**INSPECTOR'S REPORT ON AN APPLICATION
FOR A CERTIFICATE OF AUTHORISATION
FOR A CLOSED LANDFILL**

RE: Application by **Galway County Council** for a Certificate of Authorisation for a closed landfill at **Tuam Historic Landfill, Rinkippeen, Tuam, County Galway.**

Certificate of Authorisation Register Number **H0192-01.**

Figure 7: Trial pit (TP) and groundwater (A/AP/RC/BH/GW), dual gas & leachate (BH0), gas (BHLFG) and surface water (SW) monitoring locations

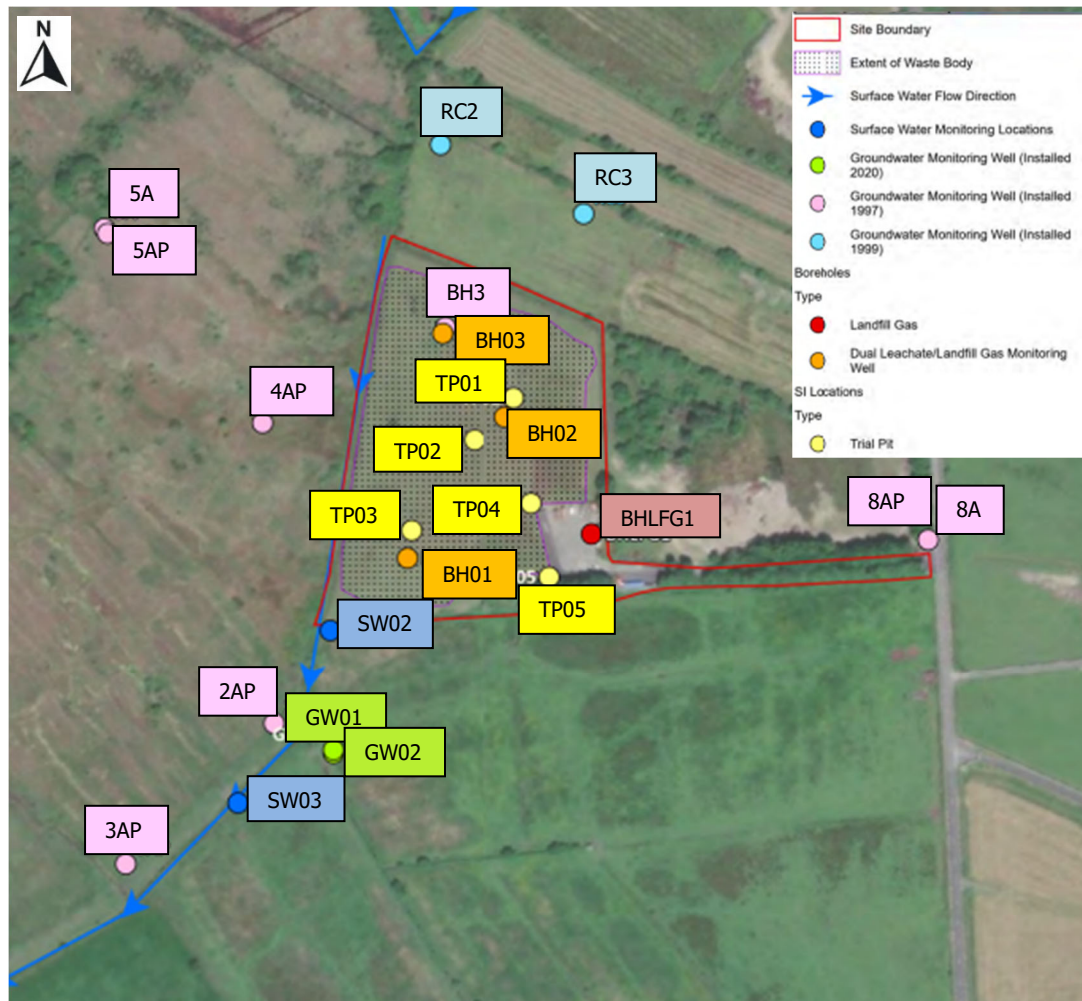
The monitoring results show very high concentrations of both methane (maximum concentration of 67.7% v/v in BH03) and carbon dioxide (maximum concentration of 17.2% v/v also in BH03) measured in the three boreholes, BH01 to BH03, within the waste body. It is noted that these three boreholes are leachate monitoring boreholes and therefore, the gas readings may not be representative of the actual gas conditions within the landfill. EPA Landfill Monitoring Manual² states that leachate monitoring wells are inappropriate for gas monitoring purposes within the waste body. However, the monitoring results do show that landfill gas is being generated within the landfill and may be migrating outside the waste body, as the 1.5% trigger level for carbon dioxide outside the waste body was exceeded in July 2020 at three locations (1.8% v/v at 8A, 1.7% at 8AP and 1.5% v/v at RC3).

It is noted that the applicant did not recommend any gas management system for the landfill. Considering the gas monitoring results and the proposed installation of a landfill cap which may result in the lateral migration of gas outside the waste body, it is considered that passive gas vents are appropriate for the site. Accordingly, Condition 3.1(d)(i) requires installation of passive gas vents within the waste body and that

Due to the fact that the landfill gas is being generated and migrates outside the waste body, as recorded in boreholes 8A, 8AP and RC3, Condition 3.1(d)(i) requires installation of gas vents within the waste body. Condition 3.1(d)(i) further requires that spacing between the gas vents needs to achieve adequate gas venting.

Figure 9: Area of the existing cap proposed to be repaired

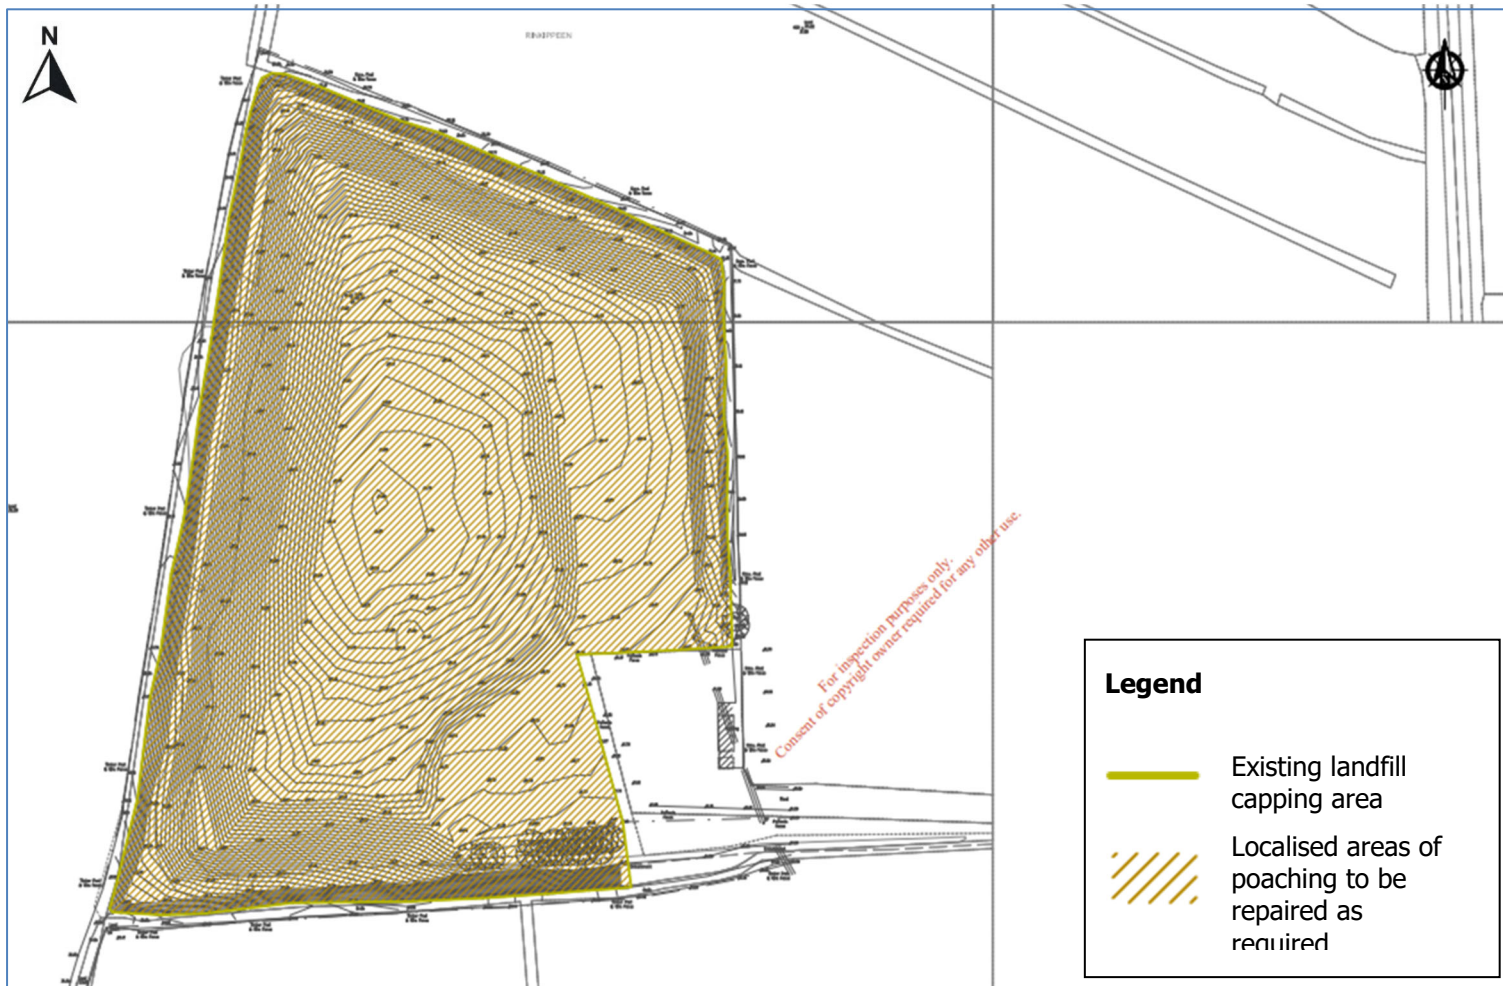
<p>Proposed remedial actions:</p>	<p>The applicant considered the following remedial measures as the feasible options:</p> <p><i>1 Landfill capping</i></p> <p>Tier 3 assessment proposes that landfill capping works be limited to the repair of the existing cap where erosion, poaching and exposure of the GCL has occurred and states that additional soil may be required for repairs and resurfacing of the cap. Figure 9 shows the extent of the existing landfill cap and area of poaching proposed to be repaired.</p> <p>Condition 3.1(c) requires a low permeability landfill cap over the entire waste body, minimum 1m with 1mm thick low permeability geomembrane, or equivalent, to achieve a hydraulic conductivity of less than or equal to $1 \times 10^{-9} \text{m/s}$. Condition 3.1(c)(iii) requires the reprofiling of the gradients to provide for rainwater run-off from the surface of the landfill. Condition 3.13 requires that only greenfield soil and stone, including greenfield soil and stone that meets by-product criteria, or soil and stone of equivalent nature and character, in terms of chemical and physical composition, can be imported for use in remedial, corrective, or other engineering works at the site.</p>

Accordingly, Condition 3.1(c) requires the installation and maintenance of a low permeability landfill cap over the waste body in accordance with the EPA Landfill Manuals – Landfill Site Design.

Figure 10: Existing and proposed monitoring locations

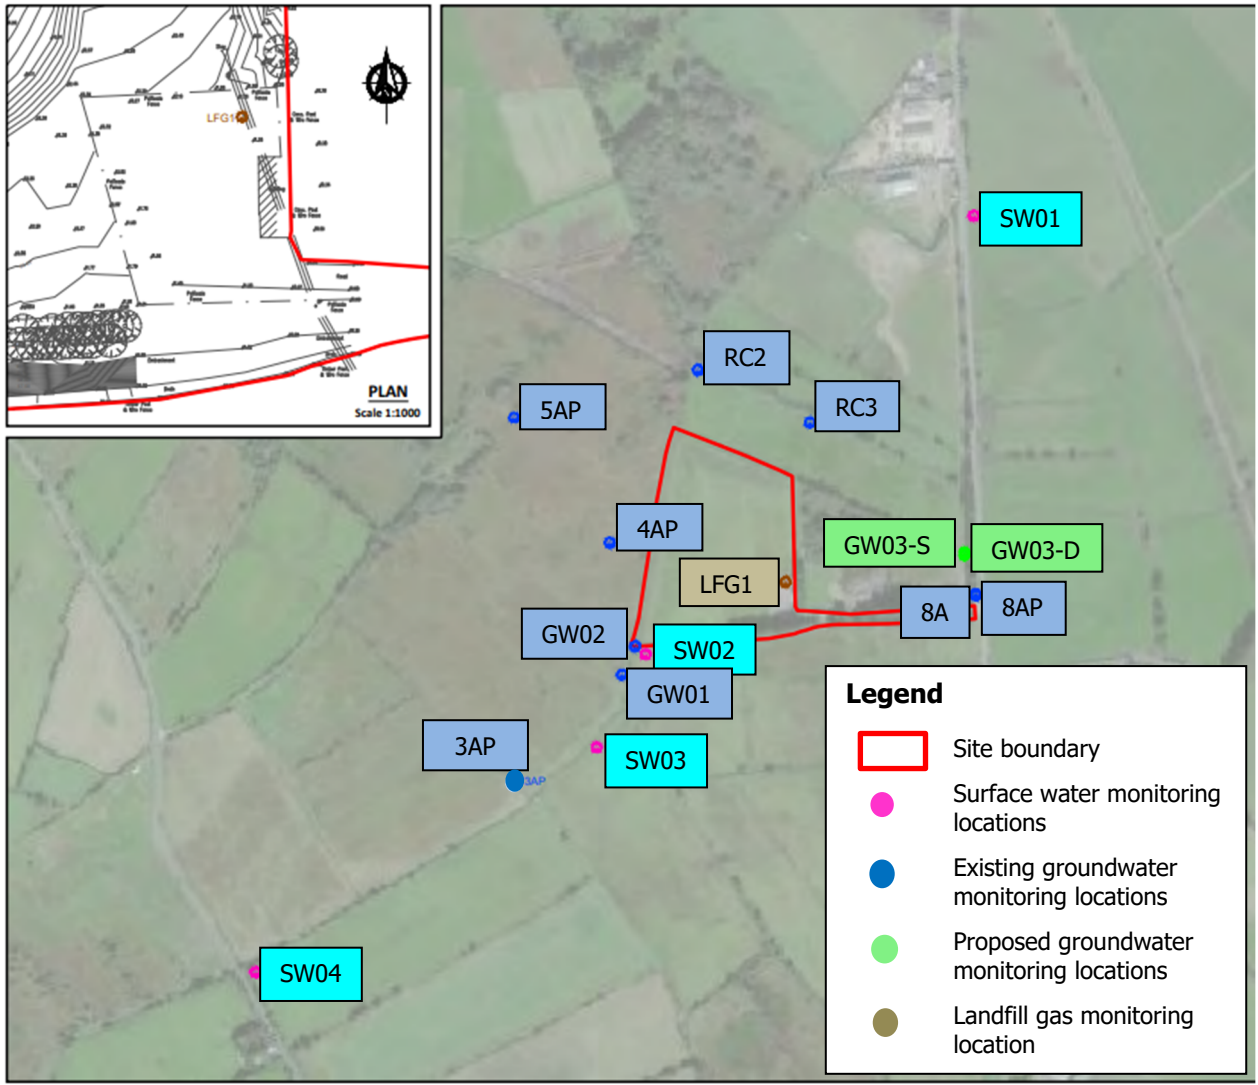
The Tier 3 assessment recommends the addition of two upgradient monitoring locations GW03-S (shallow well) and GW03-D (deep well), as shown in Figure 10, to become part of the continual groundwater monitoring for the site. It is noted however that these wells are located in close proximity, c.40m north, of the existing upgradient boreholes 8A and 8AP. Accordingly, it is considered that monitoring at the existing upgradient locations is considered sufficient.

The Tier 3 recommends gas monitoring at the existing boreholes 4AP, 5AP, 8A and 8AP, GW01, GW02, RC2, RC3 and LFG1 at the civic amenity facility, as shown in Figure 10. As stated above, boreholes 8A and 8AP are located only a few metres apart from each other therefore, only one of them, borehole 8A, is recommended to be monitored in Schedule A.2.

The Tier 3 assessment further recommends a quarterly monitoring of the downgradient boreholes 4AP, 5AP, GW01, GW02 and the annual monitoring of the cross-gradient boreholes RC2 and RC3 and the upgradient boreholes 8A and 8AP. It is noted however that boreholes 8A and 8AP are located only a few metres apart from each other therefore, only one of them, borehole 8A, which is deeper (6.75m deep) than 8AP (1m deep), is recommended to be monitored.

It is considered that a quarterly monitoring frequency for all groundwater monitoring locations is appropriate. Accordingly, this is set out in Condition 3.9(e) and Schedule A.4. Condition 3.12 provides for change of the monitoring scope if necessary, following evaluation of test results and/or relevant proposals.
